**City Planning Commission Meeting  
Tuesday, December 9, 2014**

**PRELIMINARY STAFF REPORT**

**Zoning Docket:** 119/14

**Request:** This is a request for an Amendment to Ordinance No. 24,006 MCS (Zoning Docket 039/10, which granted a zoning change from an LP Lake Area Neighborhood Park District to an LRM-1 Lake Area Low-Rise Multiple-Family Residential District and a Conditional Use to permit the renovation and expansion of an existing television station and associated accessory equipment) to permit the further expansion of a television station and associated accessory equipment, in an LRM-1 Lake Area Low-Rise Multiple-Family Residential District.

DESIGNER: SH PROJECT: RS  
DRAWN BY: SH DATE: 08-29-14  
PROJECT TITLE: LANDSCAPE PLAN  
PROJECT NO.: INTERNO:  
**11065 L101**

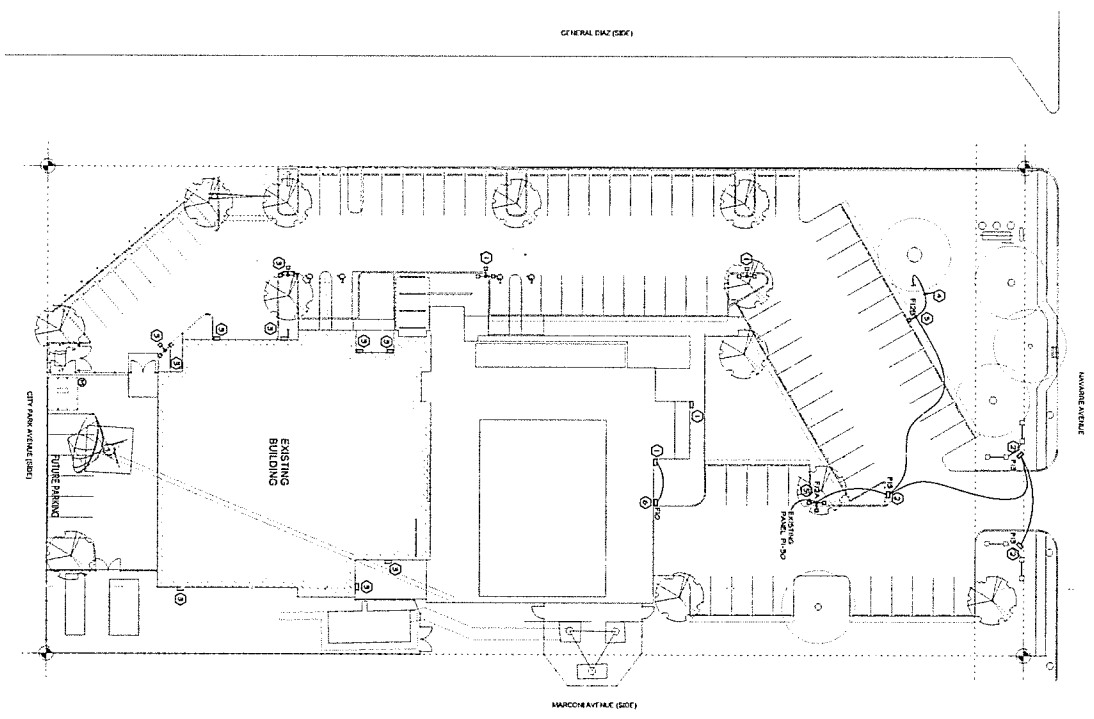
The landscape plan shows a combination of trees and groundcover throughout the site. The proposal includes a tree protection plan for existing trees on the site and it includes instructions on how the trees will be protected during construction. The existing trees include five (5) live oak trees in front of the building and seven (7) crepe myrtles along an old walkway from Navarre Avenue. The applicant proposes to retain and protect the live oak trees and remove the crepe myrtles. The proposal includes the addition of Shumard oak trees in front of the building and in the parking lot islands. Shrubs and groundcover are proposed along the new driveway entrance and within planters adjacent to the building. The landscape plan includes a plant schedule with the genus, species, size, and quantity of proposed plant materials. The landscape plan must be approved by the Department of Parks and Parkways and the plans must be stamped by a licensed Louisiana landscape architect. The current proviso includes language in reference to landscaping for the existing one-story structure. This is no longer necessary given that the building must be demolished for Phase II. Therefore, the staff reiterates the following portions of the existing proviso:

- The developer shall submit a detailed landscape plan prepared by a licensed Louisiana landscape architect, subject to final approval by City Planning Commission and the Department of Parks and Parkways indicating the following:

- A tree preservation and protection plan for the existing oak trees.
- The species, size, location, and irrigation of all proposed plant materials within the common areas, with the applicable remarks.

- ~~A non-invasive vine (such as creeping fig) shall be continuously planted along the façade of the existing WYES station building facing Navarre Avenue, and be allowed to overtake said building.~~

- All residual areas in the parking area, which are not used for parking or vehicular access, shall be landscaped with trees, shrubs or groundcover.
- A landscaped island shall be required every ten (10) continuous parking spaces, to include the planting of a minimum of one (1) shade tree, shrubs and/or ground cover.

SITE PLAN - LIGHTING PHOTOGENESIS

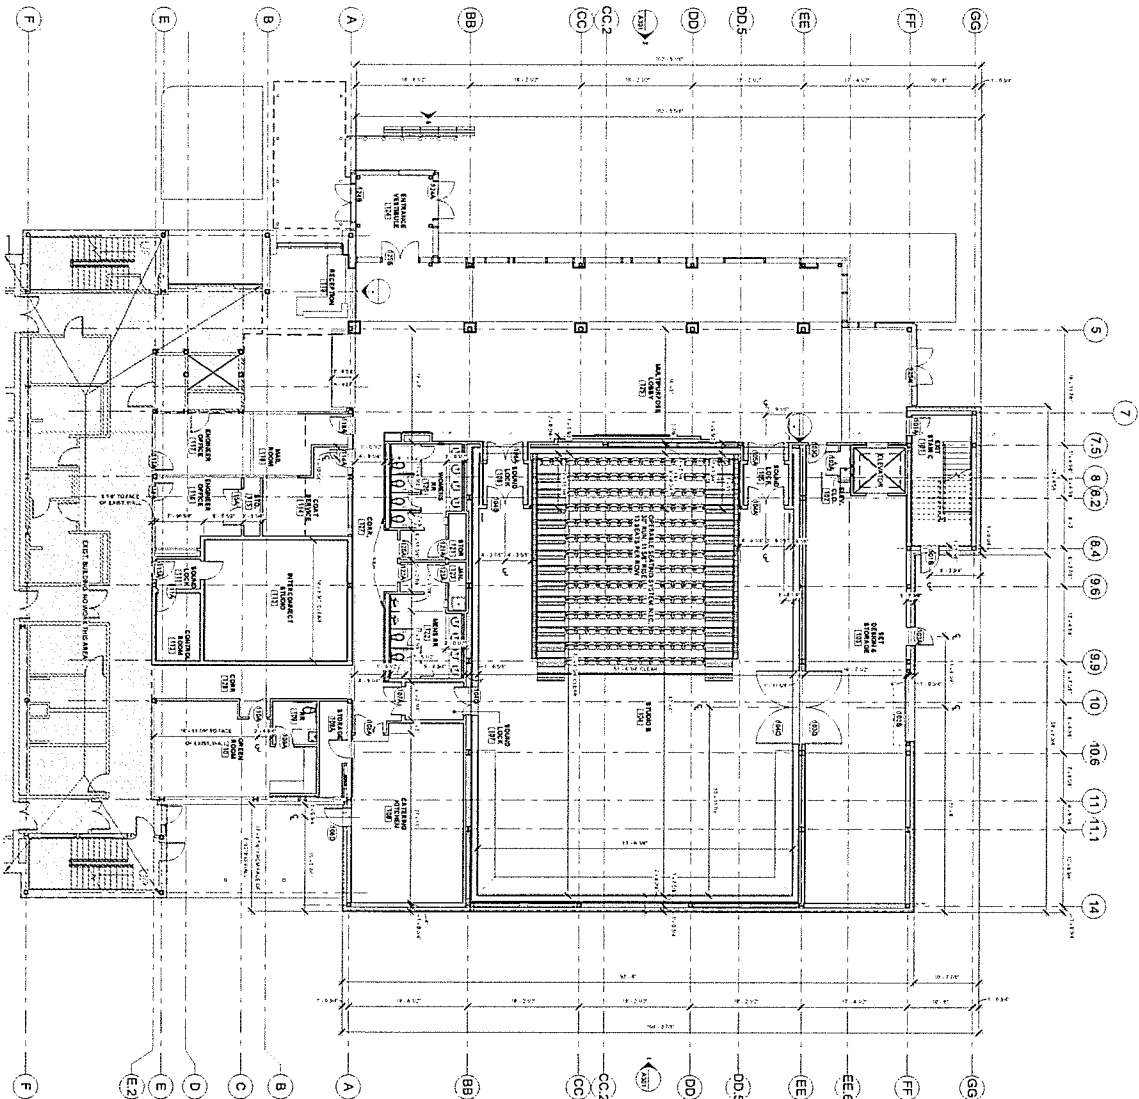
The applicant has submitted lighting and photometric plans. The lighting plan shows pole mounted lights in the parking lot and new lights proposed in the front parking areas. Wall mounted lights are shown on the front façade of the proposed addition. Lights are proposed for the new signage at the entrance to the proposed driveway.

There are residences across Navarre Avenue from the site. The photometric plan does not indicate that illumination will extend beyond the Navarre Street right-of-way. The height and type of light fixtures are not indicated. The following revisions are recommended:

- ~~The developer shall submit an illumination plan indicating the location, height and specifications of lighting for the building and the parking lot area, subject to review and approval by the City Planning Commission staff.~~ **The applicant shall submit specifications for the lights and revise the lighting plan or the elevations to indicate the height of the proposed light standards, subject to the approval of the staff of the City Planning Commission. Light standards shall be limited in height to twenty-five feet (25') and shall be directed away from nearby residential areas.**
